UNITED STATES PATENT AND TRADEMARK OFFICE

APPLICATION NO.	FILING DATE	FIRST NAMED INVENTOR	ATTORNEY DOCKET NO.	CONFIRMATION NO.
10/002,049	11/02/2001	Charles F. Malone	KPF / 54	4375

Office Action Summary

DETAILED ACTION

FIG. 3

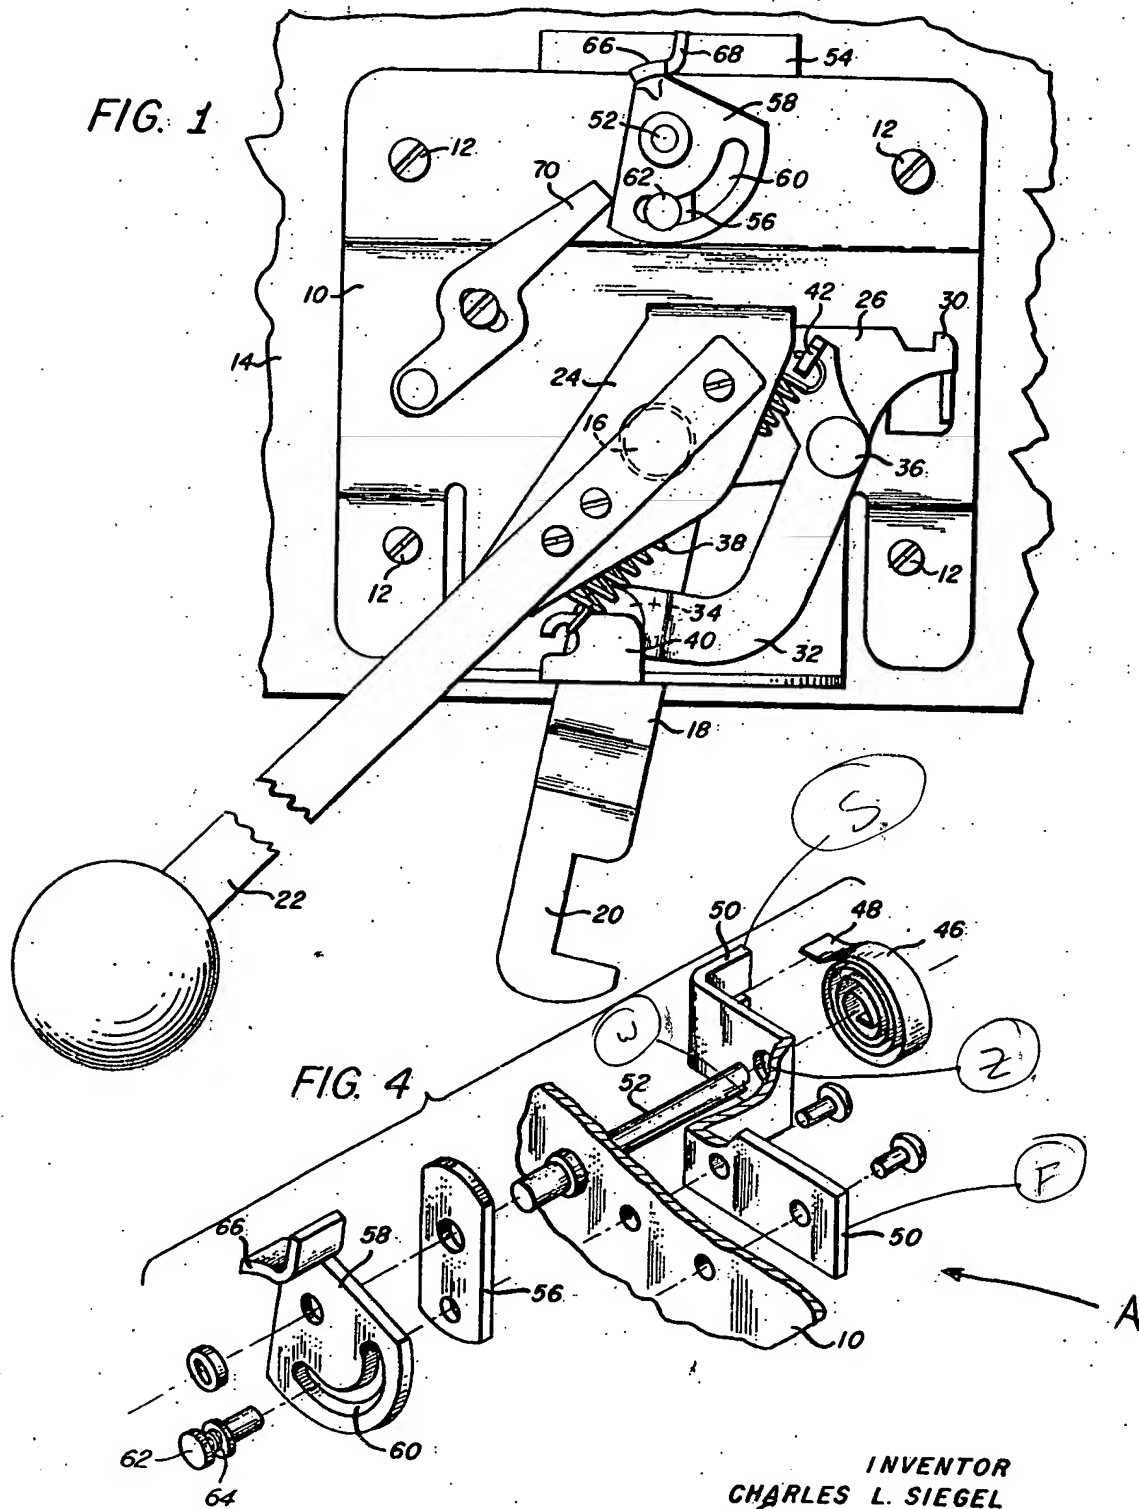
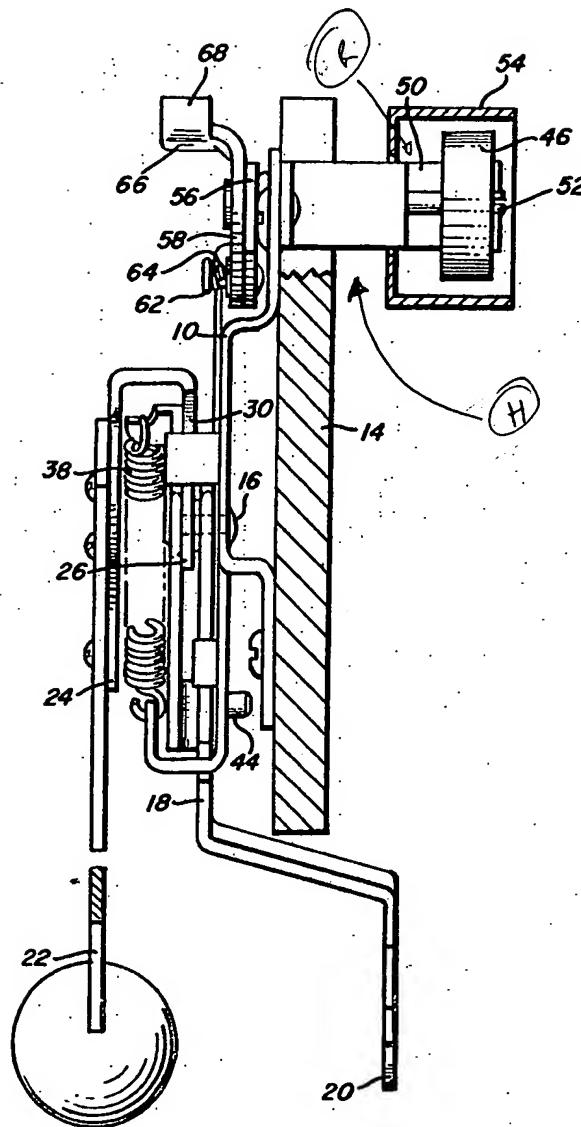
defines encompass as to “include”, and as shown in Fig. 4, Siegel’s first spring includes lock member (50) via pin (62). In regards to claim 12, Siegel’s slot (W) is elongated, see Fig. 4. As it concerns claim 13, Siegel’s oven door locking mechanism further comprises a latch mechanism defining a lock hole (generally H in Fig. 3) adapted to receive said lock member, see Fig. 3; and a mounting bracket (10) wherein said first spring is affixed to said mounting bracket via pin (62). In regards to claim 14, Siegel’s thermally responsive element is a bimetallic leaf secured at a first end (48) and defining said slot at a second end; see col. 3, lines 54-55. Regarding claim 15, Siegel’s lock hole comprises a receiver member (R), see Fig. 3. As it concerns claim 16, Siegel’s receiver member is a bushing. For the purposes of clarification, the *Merriam-Webster’s Collegiate Dictionary* 10th Edition defines bushing as “a mechanical part used to... serve as a guide”. Claim 17 is rejected as set forth above. In regards to claim 19, Siegel discloses an oven door locking mechanism which locks the oven door at a temperature substantially higher than that at which it unlocks the oven door as set forth above. The Examiner notes that Siegel’s oven inherently has a substantially uniform temperature between the oven air and the oven door locking mechanism and since the applicant has not claimed any structure the further limit the oven door locking mechanism, the recitation has not been given any patentable weight. In regards to claim 20, Siegel comprises a thermally responsive element (46) capable of actuating locked and unlocked states of the oven door at different temperatures as set forth above.

5. The Examiner notes that Siegel and Fox were provided with annotations to accurately communicate to the applicant the specific structures the Examiner was referring to in the rejections. For the applicant's benefit, the Examiner has attached the appropriate figures to this Office Action.
